THE BEACH AT WOODMOOR

LETTER OF INTENT

MAY 2017

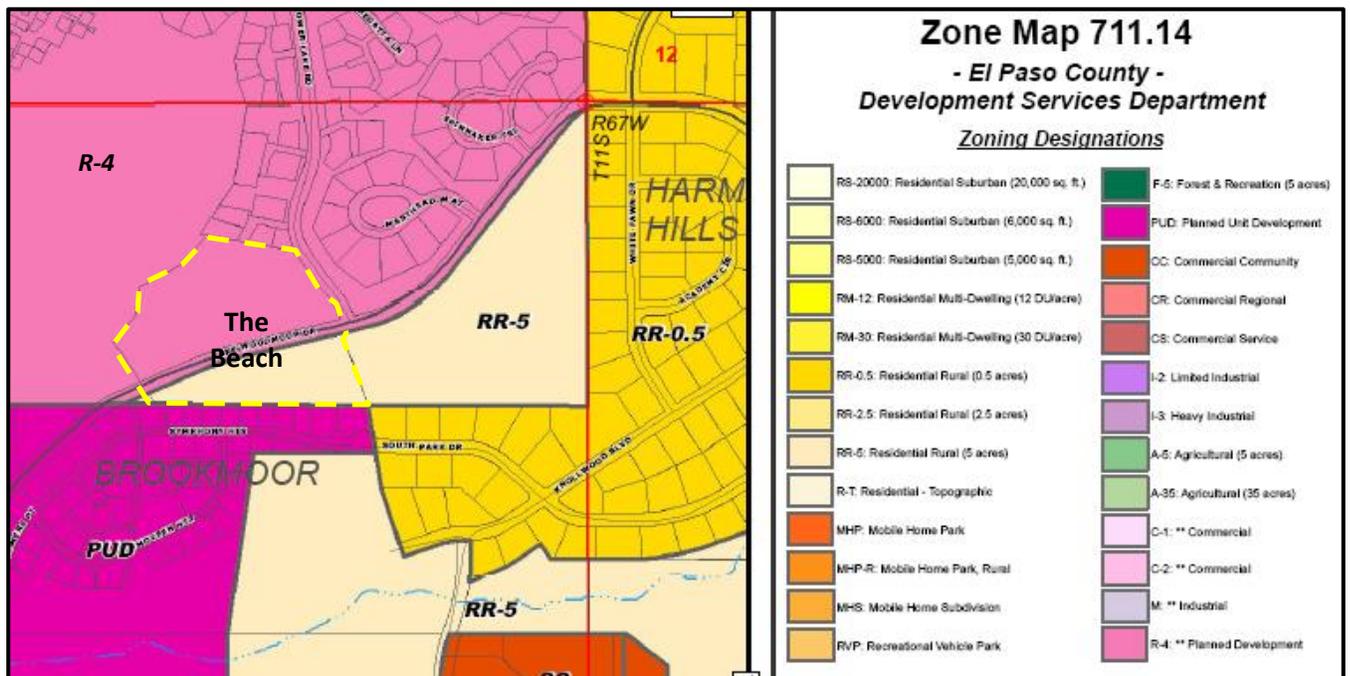
reduced from what to what?
